**LRB-2021-37 - 21/01075/FLL - Erection of dwellinghouse and garage, installation of an air source heat pump and associated works, land 160 metres north west of Craighton House, Cleish**

**PAPERS SUBMITTED  
BY THE  
APPLICANT**

I am directed by the Planning Authority under the Town and Country Planning (Scotland) Acts currently in force, to refuse your application registered on 28th July 2021 for Planning Permission for **Erection of dwellinghouse and garage, installation of an air source heat pump and associated works Land 160 Metres North West Of Craigton House Cleish**

North West Elevation

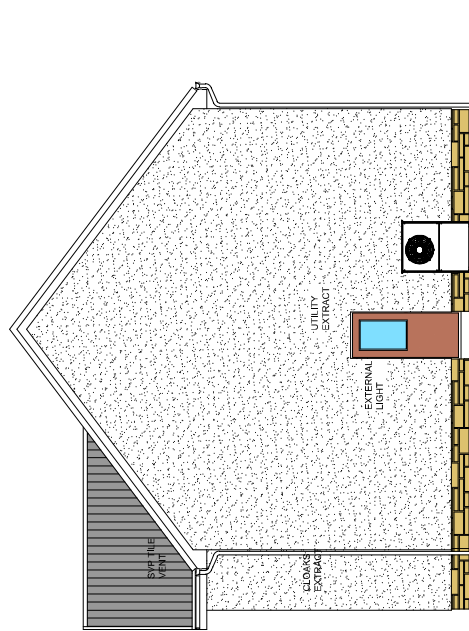
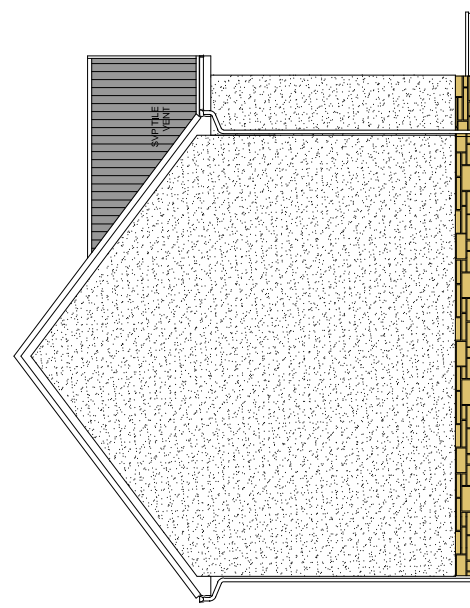
The plans indicate that the ASHP is to be installed at the northwest elevation of the proposed dwellinghouse.

**EH11** All plant or equipment shall be so enclosed, attenuated and/or maintained such that any noise therefrom shall not exceed Noise Rating 35 between 0700 and 2300 hours daily, or Noise Rating 20 between 2300 and 0700 hours daily, within any neighbouring residential property, with all windows slightly open, when measured and/ or calculated and plotted on a rating curve chart.
